1CAN041502

**SUBJECT:** Responses to Request for Additional Information  
Update the Reactor Coolant System Pressure and Temperature and the  
Low Temperature Overpressure Protection System Limits  
Arkansas Nuclear One, Unit 1  
Docket No. 50-313  
License No. DPR-51

# **Response to Request for Additional Information on Reactor Coolant System Pressure/Temperature and Low Temperature Overpressure Protection System Limits to 54 EFPY for Arkansas Nuclear One, Unit 1**

ANP-3300Q4-NP  
Revision 0

FIGURE 3.4.3-1  
RCS Heatup Limitations to 5431 EFPY

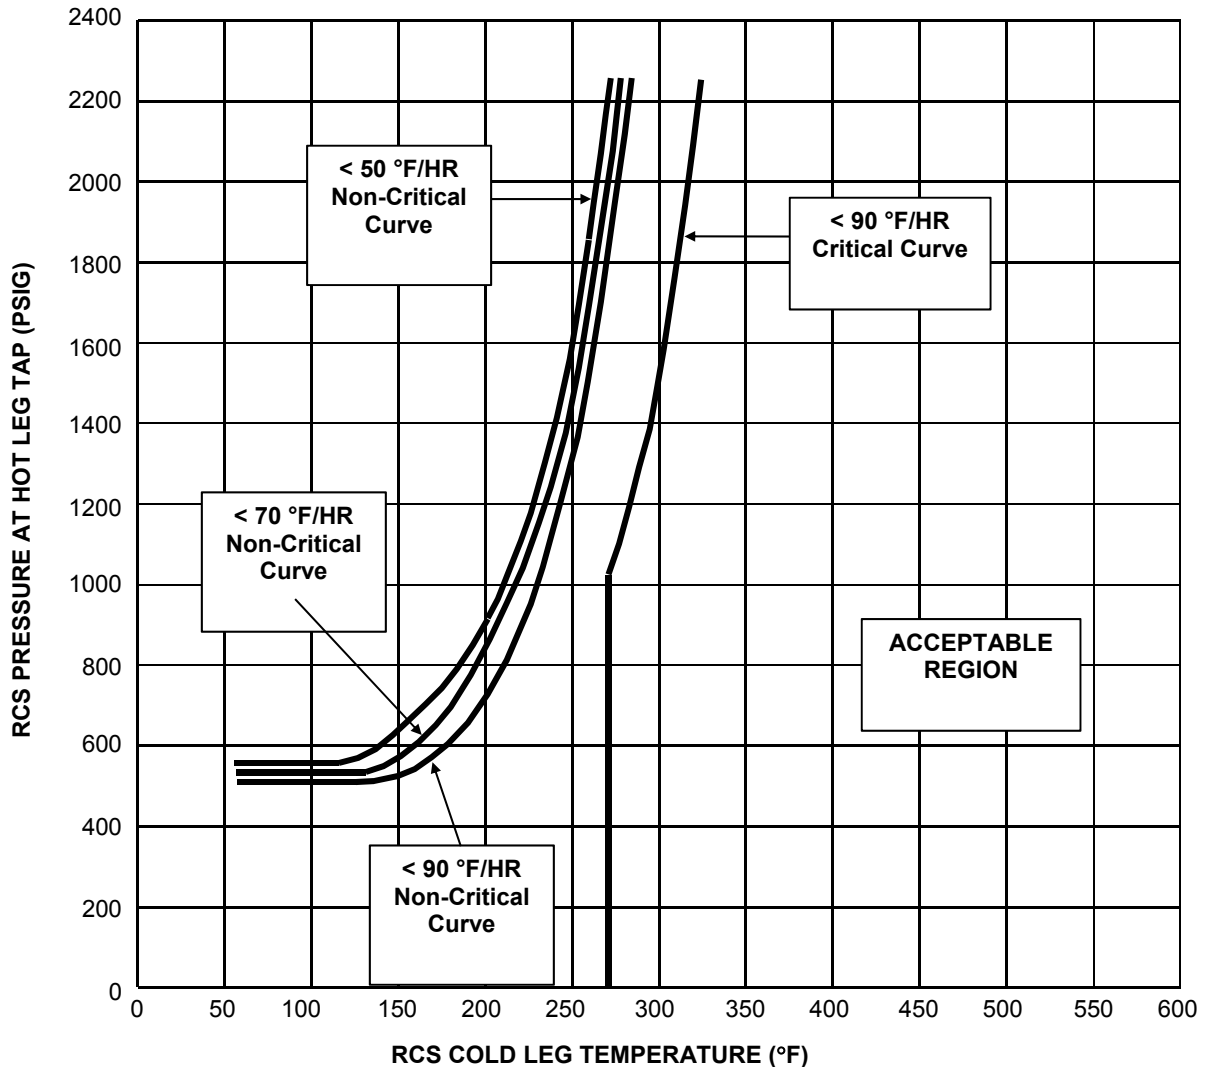
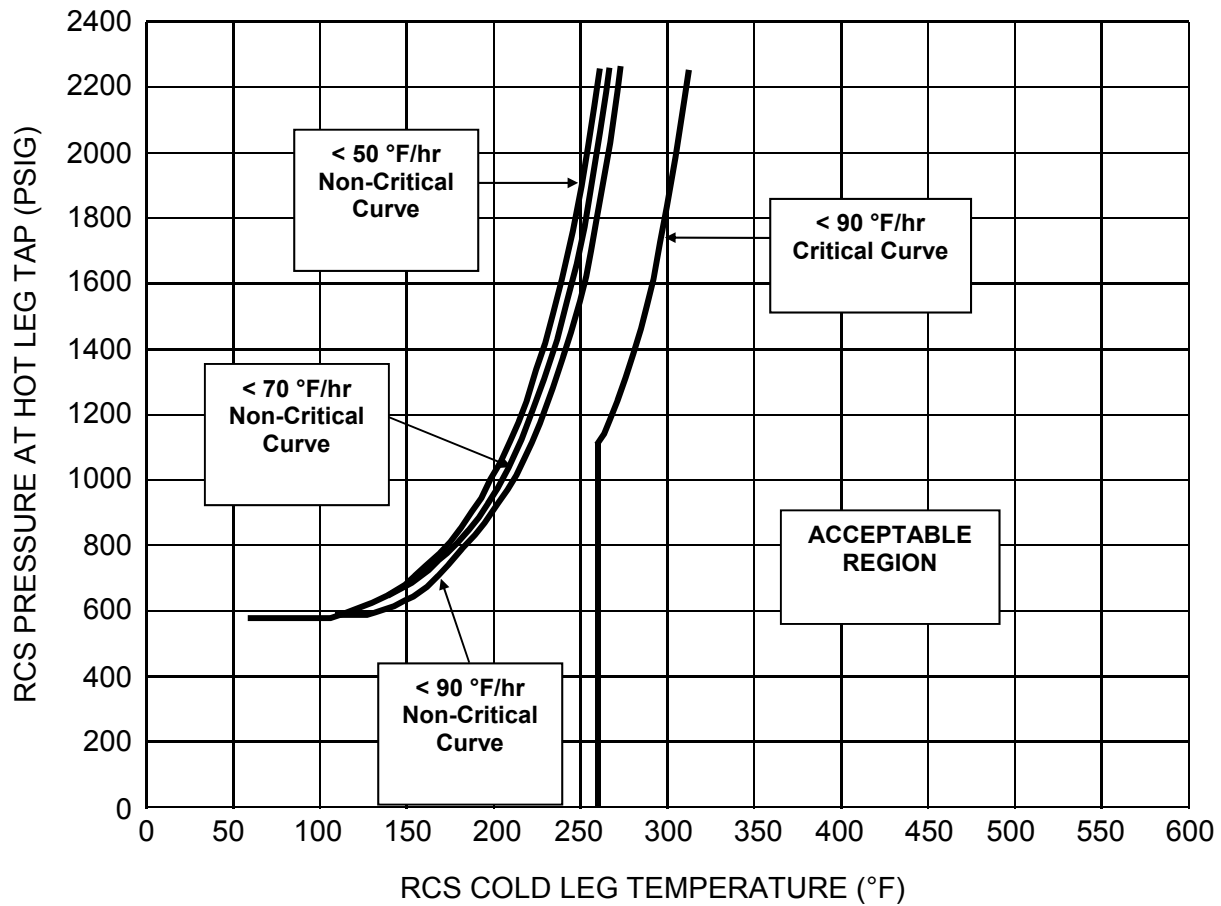
“In proposed new TS Figure 3.4.3-1, the reactor coolant pump (RCP) restrictions were modified from no RCPs allowed to be operating at < 84 deg F,  $\leq 2$  between 84 and 225 deg F and  $\leq 3$  between 225 deg F and 300 deg F to  $\leq 3$  between 100 deg F and 300 deg F and no RCPs allowed to be operating at < 100 deg F. Please provide a justification for this change, including any impacts on the limiting mass and energy analysis.”

Revisions to Notes 3 and 4 of the proposed TS, Figure 3.4.3-1 (RCS Heatup Limitations to 54 EFPY) are based on ANP-3300, Revision 1, Section 4.6.1, and Table 7-5. The RCP restrictions and allowable heatup rates in Notes 3 and 4 reflect the analytical input used to develop the heatup P/T curves in accordance with ASME Section XI, Appendix G, G-2215, Equation 1. As discussed in Section 1.0 above, there is an inconsistency between the description of film heat transfer coefficients used in the fracture mechanics evaluation (ANP-3300, Revision 1, Section 4.5) and the operational constraints for heatup presented in Table 7-5 (basis is limiting location pressure corrections). The inconsistency in the application of the film heat transfer coefficient was revised to accurately reflect the operational restrictions of the plant during heatup, which are correctly captured in the Note 3 and 4 definitions at 31 EFPY (TS, Figure 3.4.3-1).

The inconsistencies with ANP-3300, Revision 1 have been amended (See Section 2.5 below) such that the operating restrictions for heatup at 54 EFPY (Notes 3 and 4) are identical to the operating restrictions at 31 EFPY (Notes 3 and 4). The heatup P/T limits reported in Table 7-1 of ANP-3300, Revision 1, are not impacted by the amendment to operational restrictions. Therefore, the 54 EFPY heatup P/T limits reported in Figure 3.4.3-1 (all heatup rates) remain unchanged; Notes 3 and 4 for 54 EFPY are revised to be identical to Notes 3 and 4 for 31 EFPY as shown below. Sections 4.5, 6.0, 7.0, and Table 7-5 to ANP-3300, Revision 1 are amended to support this revision.

3. RCP Operating Restrictions:

<u>RCS TEMP</u>	<u>RCP RESTRICTIONS</u>
T > 300 °F	None
300 °F ≥ T ≥ 225 °F	≤ 3
225 °F > T ≥ 84 °F	≤ 2
T < 84 °F	No RCPs operating

4. Allowable Heatup Rates:

<u>RCS TEMP</u>	<u>H/U RATE</u>
60 °F < T ≤ 84 °F	≤ 15 °F/HR
T > 84 °F	As allowed by applicable curve

With respect to the above note changes, the LTOP P/T limits and the ERV setpoint and enable temperature are not impacted since they were generated using conservative RCP operating restrictions relative to those defined in Note 3 above. There are no changes to the limiting mass addition analysis described in Section 2.1.2.2 above.

FIGURE 3.4.3-2  
RCS Cooldown Limits to 5434 EFPY

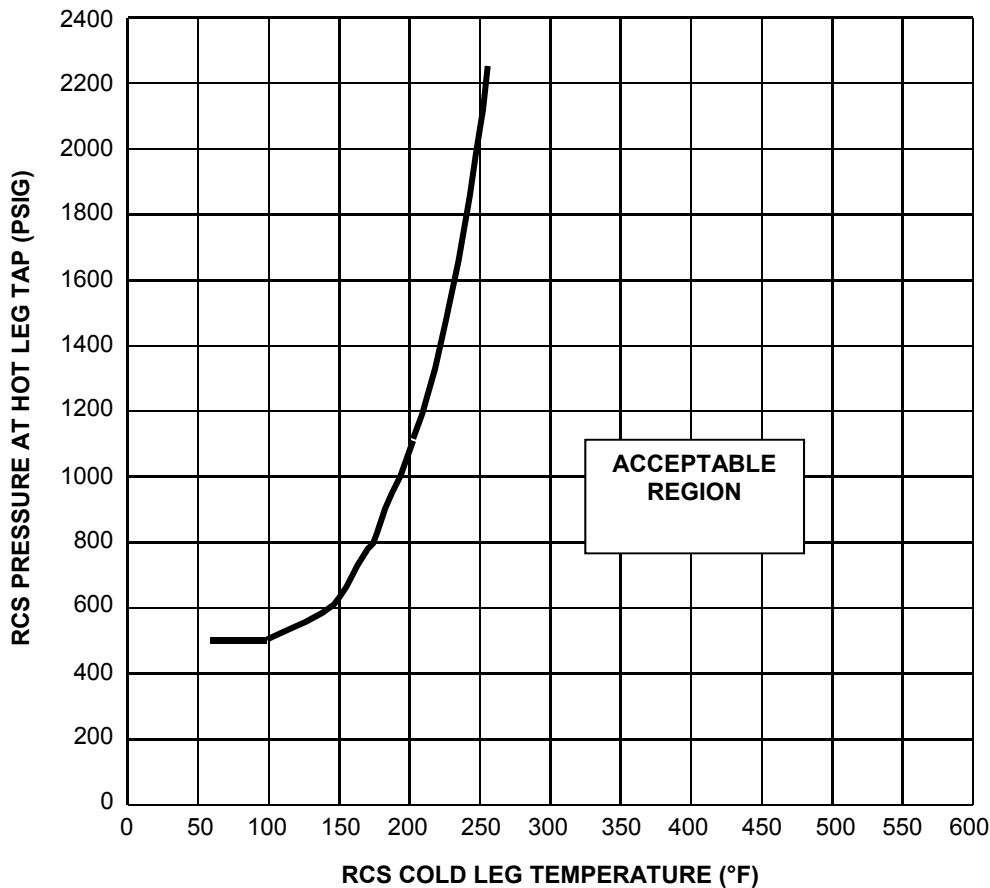
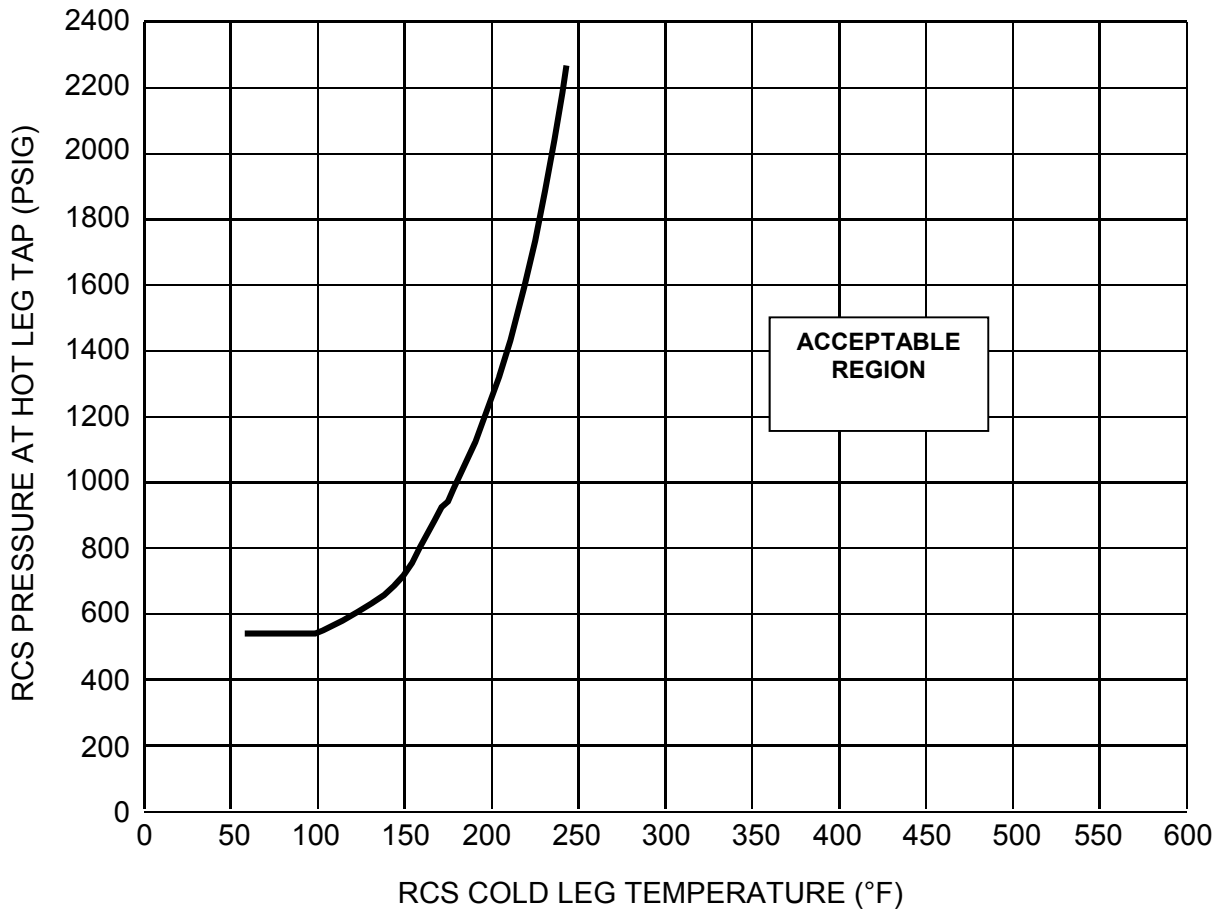
“In proposed new TS Figure 3.4.3-2, RCP restrictions were modified from no RCPs allowed to be operating at  $< 150$  deg F,  $\leq 2$  RCPs operating between 150 deg F and 255 deg F, to no RCPs operating at  $< 100$  deg F and  $\leq 2$  RCPs operating between 100 deg F and 250 deg F. In addition, Note 5 to the figure, which restricted cooldown rate to 30 deg F in 15 hours in the temperature range of 150-180 deg F was removed. Please provide a justification for these changes, including any impacts on the limiting mass and energy analysis.”

Revisions to Notes 3 and 4 of the proposed TS, Figure 3.4.3-2 (RCS Cooldown Limits to 54 EFPY) are based on ANP-3300, Revision 1, Section 4.6.2 and Table 7-6. The RCP restrictions and allowable cooldown rates in Notes 3 and 4 reflect the analytical input used to develop the cooldown P/T curves in accordance with ASME Section XI, Appendix G, G-2215, Equation 1. As discussed in Section 1.0 above, there is an inconsistency between the description of film heat transfer coefficients used in the fracture mechanics evaluation (ANP-3300, Revision 1, Section 4.5) and the operational constraints for cooldown presented in Table 7-6 (basis is limiting location pressure corrections). The inconsistency in the application of the film heat transfer coefficient was revised to accurately reflect the operational restrictions of the plant during cooldown, which are correctly captured in the Note 3 and 4 definitions at 31 EFPY (TS, Figure 3.4.3-2).

The inconsistencies with ANP-3300, Revision 1 have been amended (See Section 2.5 below) such that the operating restrictions for cooldown at 54 EFPY (Notes 3 and 4) are identical to the operating restrictions at 31 EFPY (Notes 3 and 4). The cooldown P/T limits reported in Table 7-3 of ANP-3300, Revision 1, are not impacted by the amendment to operational restrictions. Therefore, the 54 EFPY cooldown P/T limits reported in Figure 3.4.3-2 remain unchanged, with the exception of the elimination of Note 5.

Note 5 was included for 31 EFPY to cover the acid reducing phase cooldown transient where the last RCPs are assumed operating at temperatures below 200 °F. For this cooldown case, the supporting P/T limit analysis was performed such that the RCS cooldown between 150 °F and 180 °F is assumed to occur over 15 hours. Note 5 is eliminated for the updated 54 EFPY P/T limit analysis since for the last RCP trip cases analyzed in the supporting analysis, the cooldown ramp rates and step changes as defined in the TS under allowable cooldown rates is being maintained over the entire temperature range of the normal cooldown. See Section 2.5 below and the revisions to ANP-3300, Revision 1, Section 4.6.2 for further information.

Notes 3 and 4 for 54 EFPY are revised to be identical to Notes 3 and 4 for 31 EFPY as shown below, with the exception of elimination of Note 5. Sections 4.5, 4.6.2, 6.0, 7.0, and Table 7-6 to ANP-3300, Revision 1 are amended in Section 2.4 below to support this revision.

## 3. RCP Operating Restrictions:

<u>RCS TEMP</u>	<u>RCP RESTRICTIONS</u>
T > 255 °F	None
150 °F ≤ T ≤ 255 °F	≤ 2 ( <del>See Note 5</del> )
T < 150 °F	No RCPs operating

## 4. Allowable Cooldown Rates:

<u>RCS TEMP</u>	<u>C/D RATE</u>	<u>STEP CHANGE</u>
T ≥ 280 °F	100 °F/HR	≤ 50 °F in any 1/2 HR
280 °F > T ≥ 150 °F	50 °F/HR ( <del>Note 5</del> )	≤ 25 °F in any 1/2 HR
T < 150 °F	25 °F/HR	≤ 25 °F in any 1 HR

~~5. If RCPs are operated < 200°F, then the RCS cooldown rate from 150°F < T < 180°F is reduced to 30°F in 15 hours.~~

With respect to the above noted changes, the LTOP P/T limits, ERV setpoint and enable temperature are not impacted since they were generated using conservative RCP operating restrictions relative to those defined in Note 3 above.
